Early Warning  
December 14, 2018  
EW-5331

File Number: BSC 480.12

**Subject: Repair of Trainline Arrangements on Box Cars**

**Figure 1(a): Trainline Arrangement on Suspect Cars**

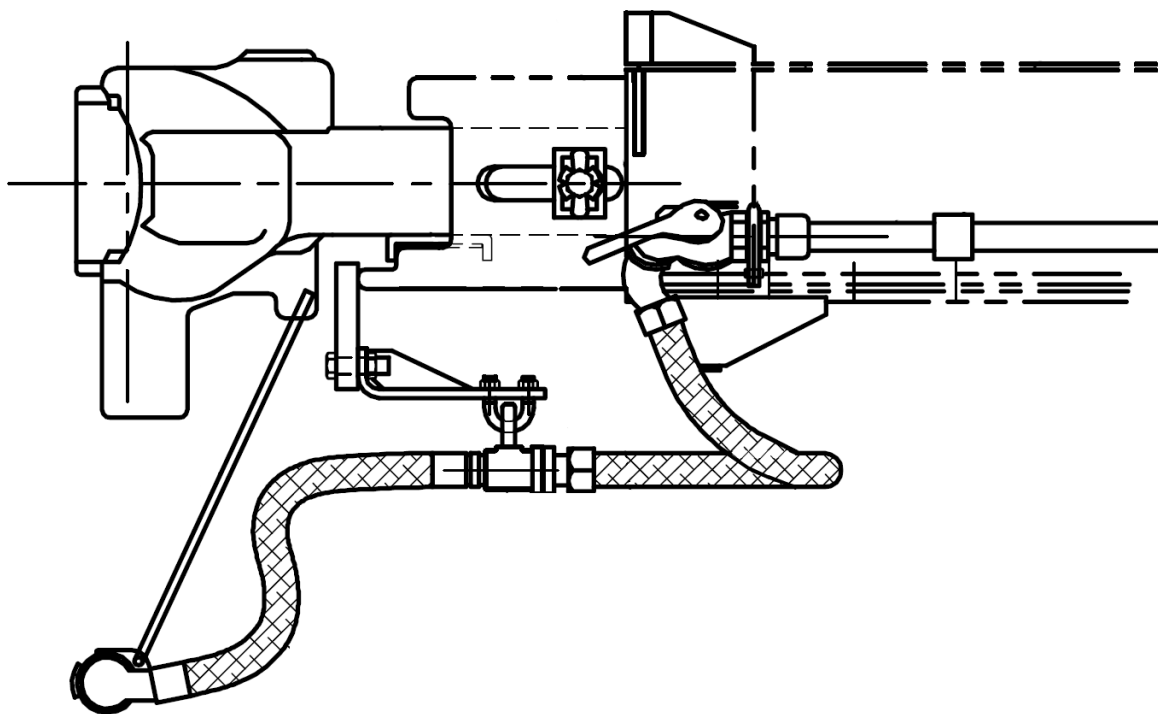
The AAR has been notified of a specific trainline arrangement/brake rigging configuration that has caused limited cases of kinked intermediate air hoses and a loss of continuity through the trainline. The arrangement had proven itself reliable based on time in service but bent components and variations in repairs led to conditions that caused the kinks.

Since the cars involved were built circa 1995, the trainline arrangement is fairly unique and predates current standards. Twenty-eight (28) suspect cars have been identified that were originally configured with both the trainline arrangement shown in Figure 1(a) and with “Hook and Eye” Brake Rigging identified in Figure 1(b). The trainline arrangement was originally configured with the following components:

- Floating Yoke with attached Trainline Support Bracket
- 39" Intermediate Air Hose
- Long Sweeping Elbow
- Trainline Support Casting with clevis connected to the Trainline Support Bracket by a U-Bolt

The correct repair is to replace trainline arrangement components, as needed, and reconfigure to a Coupler Attached Bracket based arrangement as shown in Figure 2.

**Figure 1(b): Wayside Image of Trainline Arrangement with Components Identified**

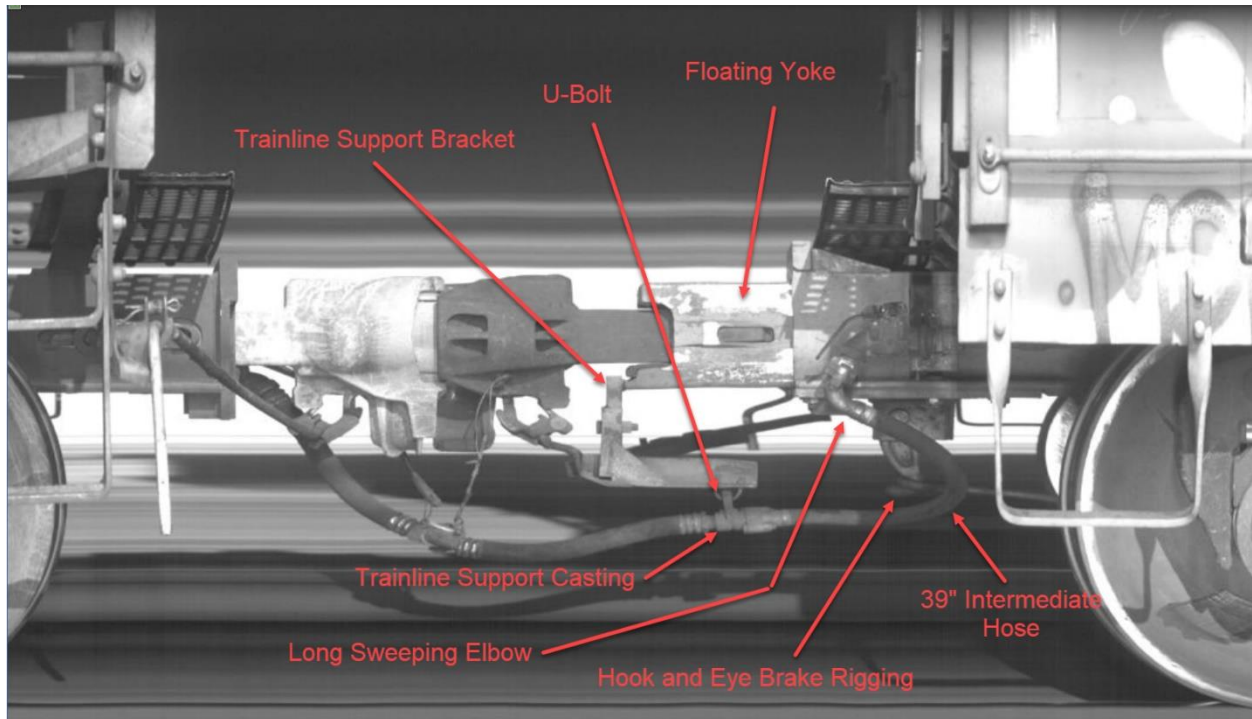
In accordance with AAR Interchange Rule 125, this Early Warning is assigned Severity Code: 06 - AAR Defined. The twenty-eight (28) cars included on this EW shall be stopped only when empty and both ends should be inspected for presence of the Hook and Eye Brake Rigging shown in Figure 1(b). If the Hook and Eye rigging is present, the car should be addressed as follows:

- MH - If the car is not configured as shown in Figure 2 and not equipped per the three bullets above, make the following repairs, as needed:
  - Remove the Trainline Support Bracket from the existing Floating Yoke
  - Install an AAR approved Coupler Attached Bracket
  - Install a 90-degree Flanged Elbow and orient to direct the hose 0 to 15 degrees outboard (see Figure 3 for proper orientation)
  - Install a 39" Intermediate Hose
  - Upon completion of the repair, return the car to service and report into the Early Warning system activity code MH - “Car repaired, return car to service”
